MEMORANDUM

SUBJECT: Final Report - ZC #14-18A RIA (Brookland Manor, Block 7)
First Stage PUD Modification and Second Stage PUD

Approved Block 7 Site Plan

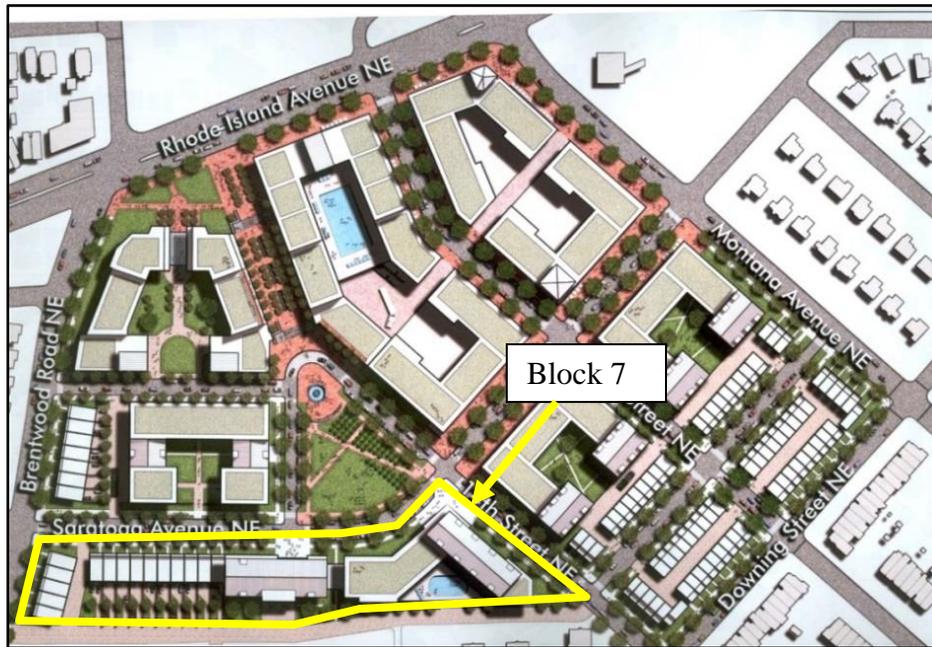
The First Stage PUD approved Block 7 for a mixture of 28 two-over-two rowhouse units, a small 28-unit apartment building and a second apartment building with 150 to 200 senior apartments as shown on the Site Plan below.

The applicant requests a modification to the approved plan to replace the two-over-two rowhouse units with an apartment building. The Block would now be developed with two apartment buildings with the senior building relocated to the western portion of the block while the second apartment building would be on the eastern portion of the block as shown on the Site Plan below. The senior building, Building A, would have 200 units and Building B would have 131 units.

Proposed Block 7 Site Plan

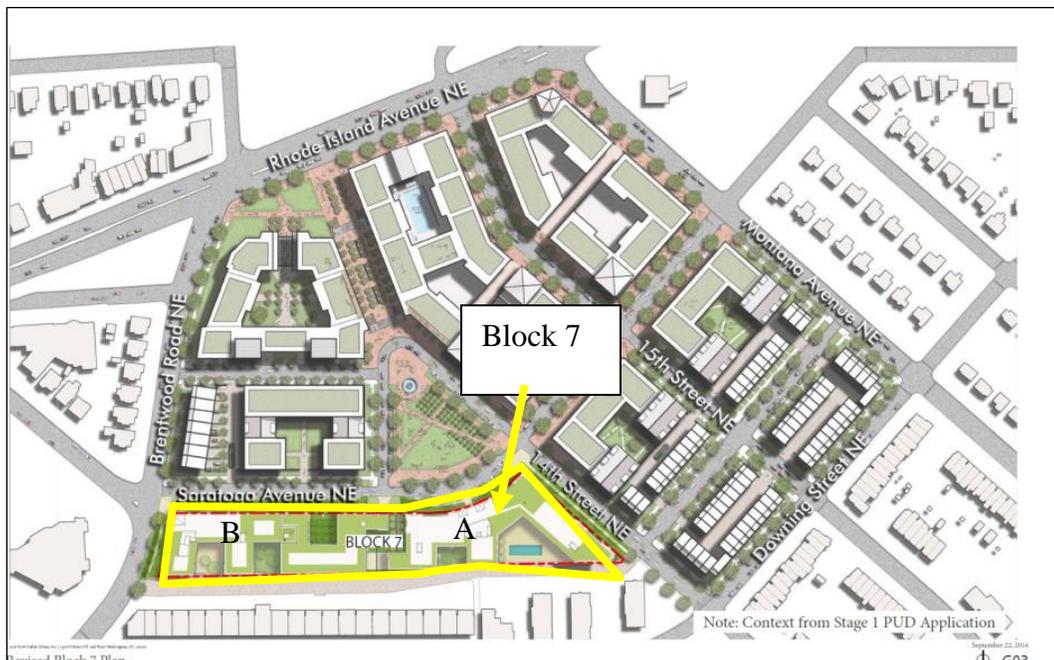
Below Grade Parking: With the change from the two-over-two units, a north-south alley proposed on the western portion of the Block is no longer necessary and has been removed. Secondly, the at-grade parking would also be eliminated and all parking will now be below grade accessed from the alley to the rear of the buildings.
